SP2019-022

The Lakes Assembly

SP2019-022 Site Plan for The Lakes Assembly: Please address the following comments (M= Mandatory Comments; I = Informational Comments)

**CASE NUMBER:** SP2019-022; Site Plan for House of Worship

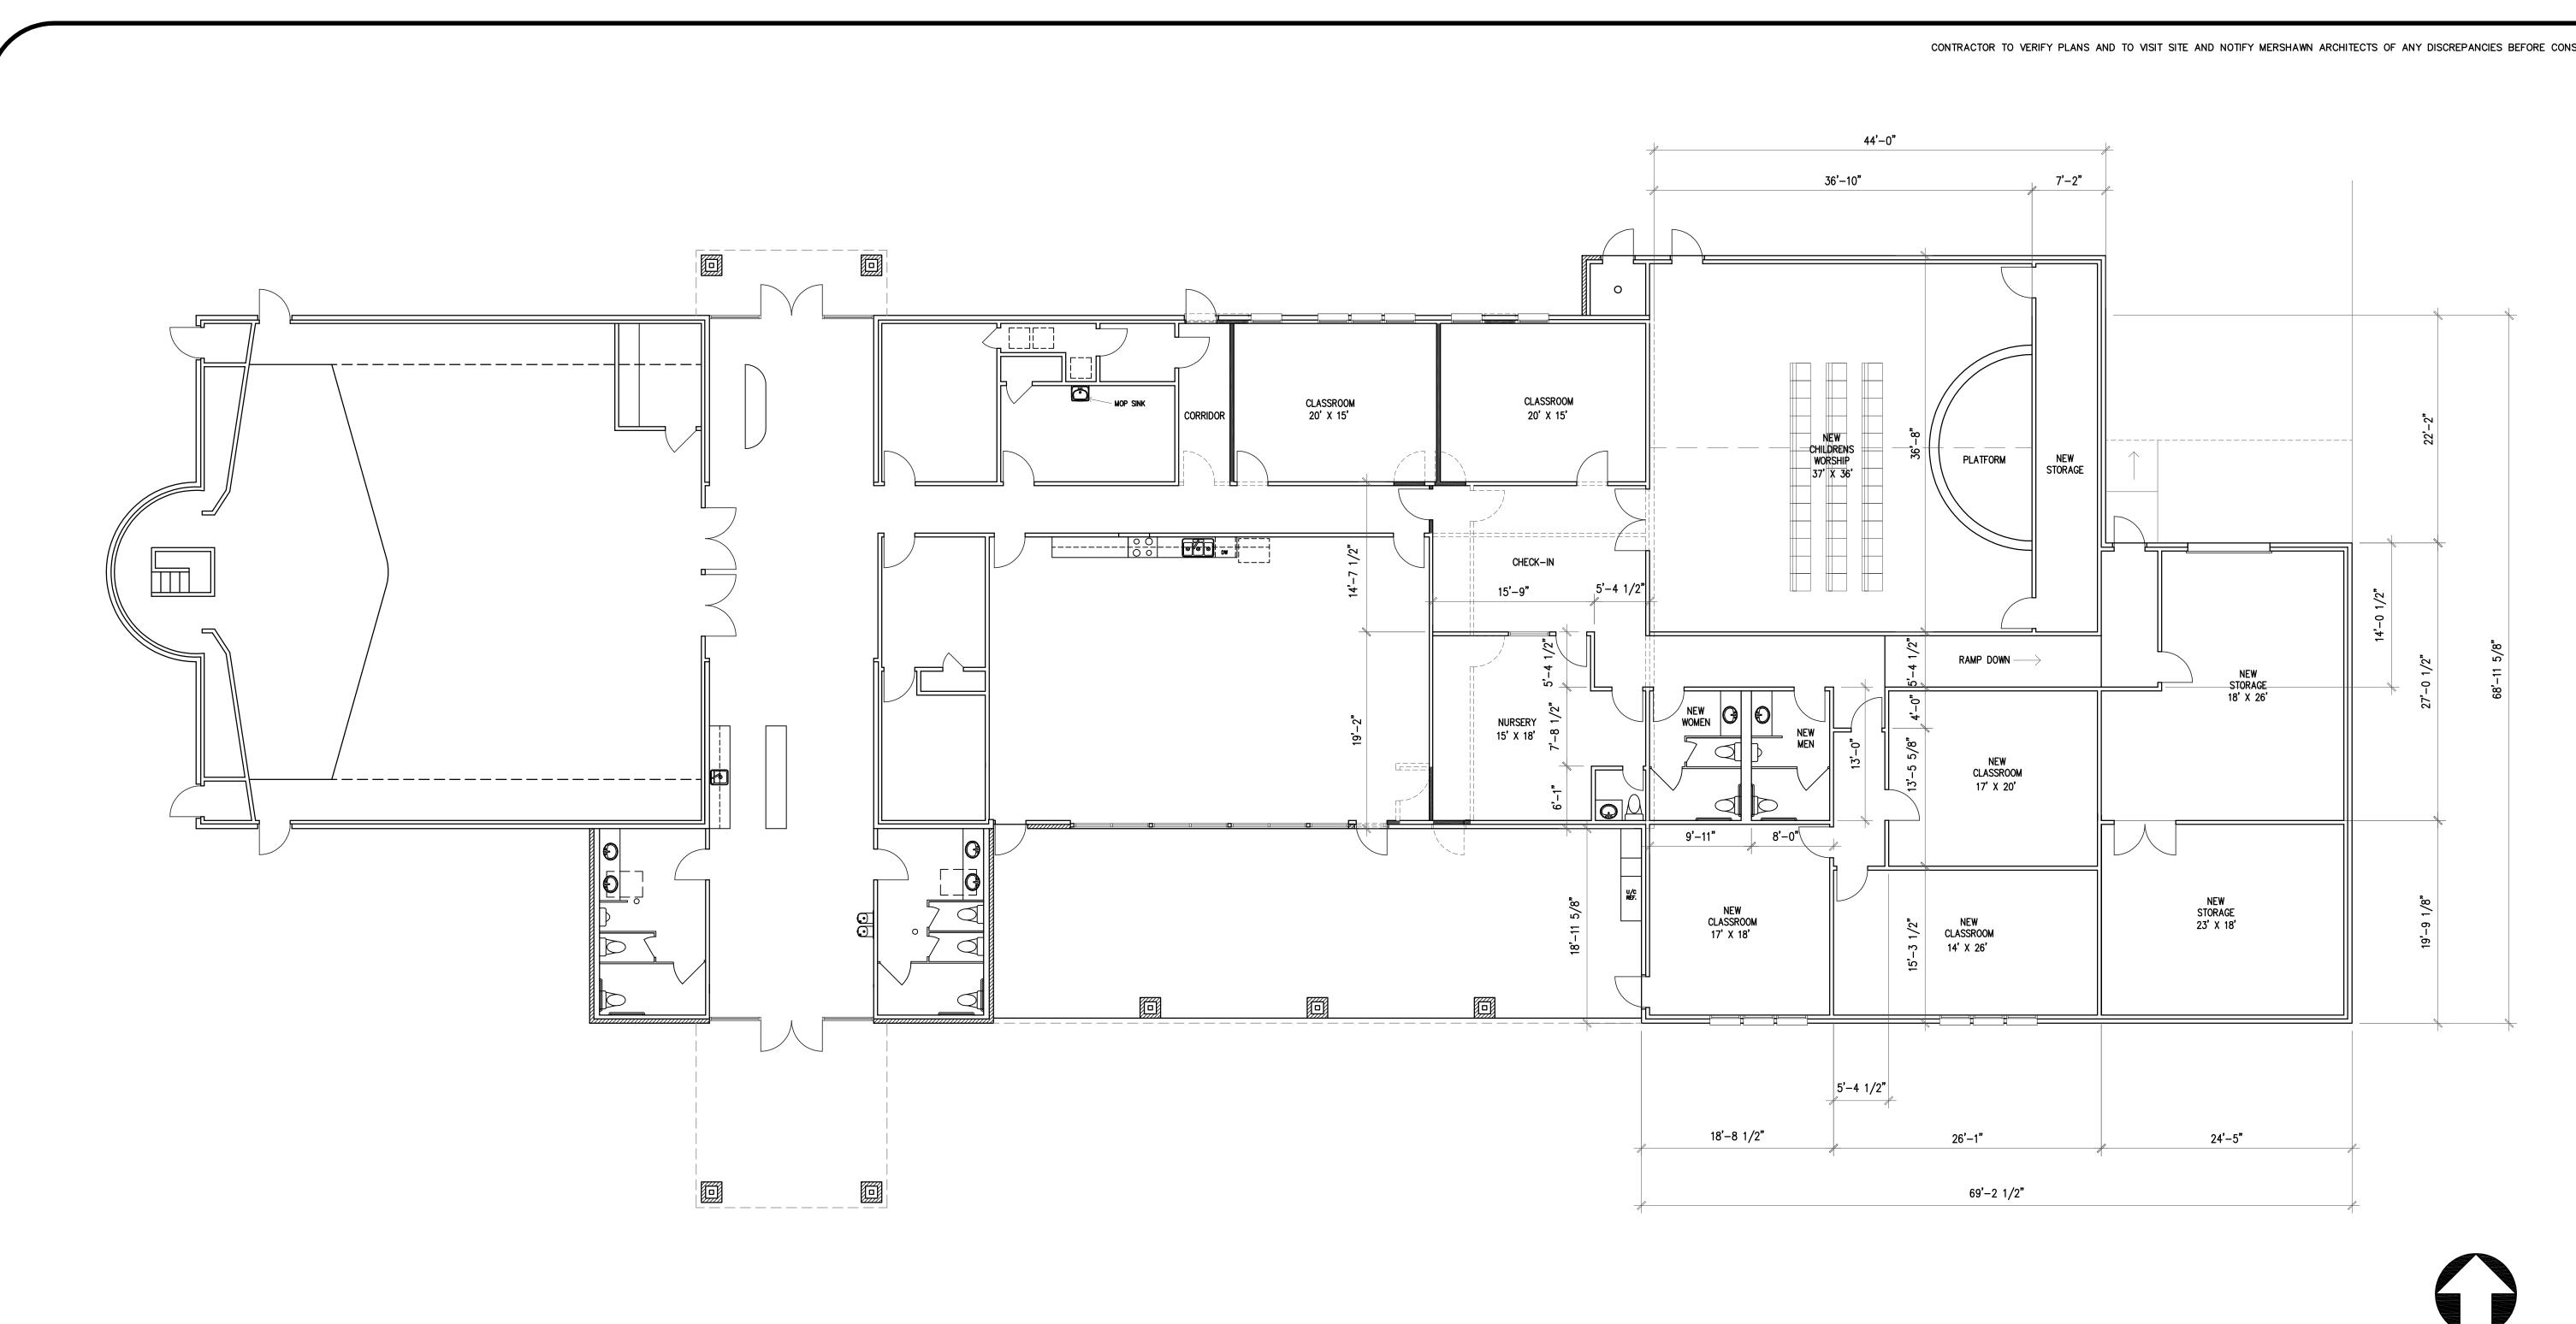
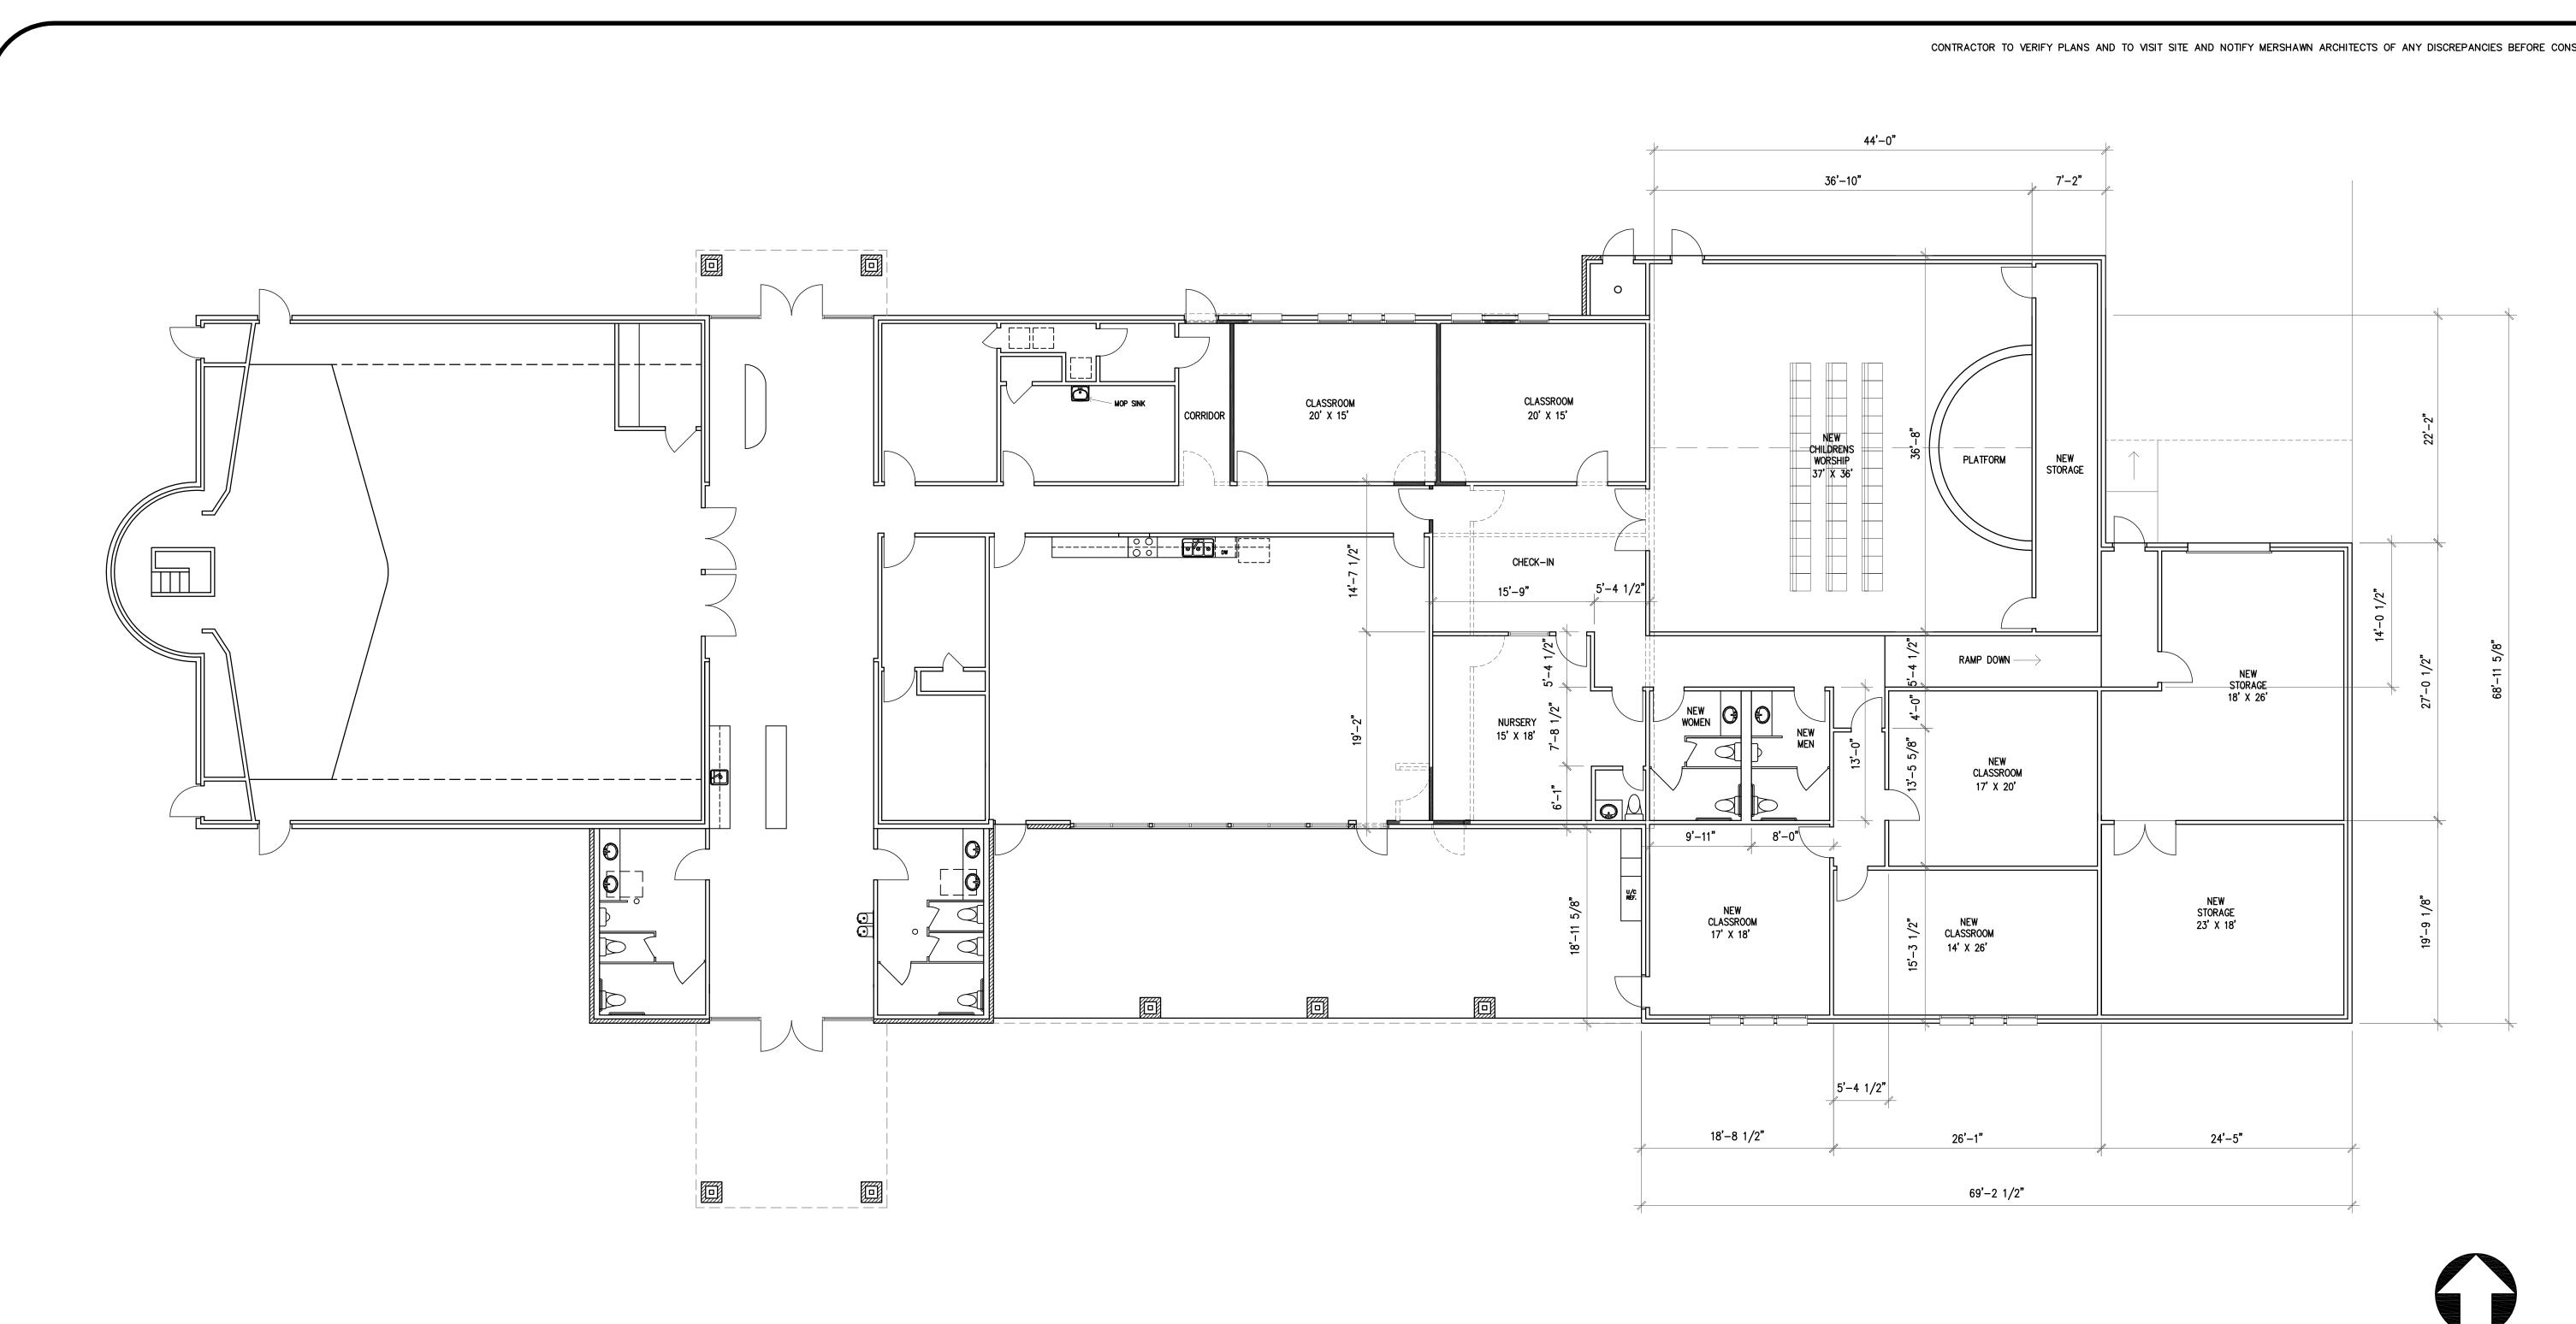
- 3. For reference, include the case number (SP2019-022) in the lower right hand corner of all pages on future submittals.
- 4. Site Plan--Will any additional exterior lighting be added?

- 5. Site Plan--Is additional parking being added?
- 6. Site Plan--Please show landscape buffer and setback adjacent to SH-66
- 7. Site Plan--Please dimension all walls

- 8. Site Plan—Please provide a light crosshatch to the existing areas.
- 9. Site Plan--Please provide a floorplan to indicate the use of the addition to ensure the parking requirement is accurate.

- 10. Site Plan--Please show and label where the mechanical equipment is and how it will be screened?
- 11. Site Plan--Please show centerline of SH-66
- 12. Site Plan--Please provide total number of seat and breakdown of existing building.

- 13. Site Plan--Please provide width of drive and radii
- 14. Site Plan--Please provide lot information on within the lot (e.g. SF, acreage, zoning, legal description, etc).

- 15. Site Plan--Please increase the font size of the items labeled on the site. Also, please note that the accessible symbols are blurry.
- 16. Site Plan--Please show and label adjacent properties.

- 17. Site Plan--Please note that a 10-foot landscape buffer including headlight screening is required along the property lines that are adjacent to residential.

- 18. Site Plan--Asshown, an exception to the horizontal articulation requirements is needed on the south elevation of the addition.
- 19. Site Plan—Please show all easements.
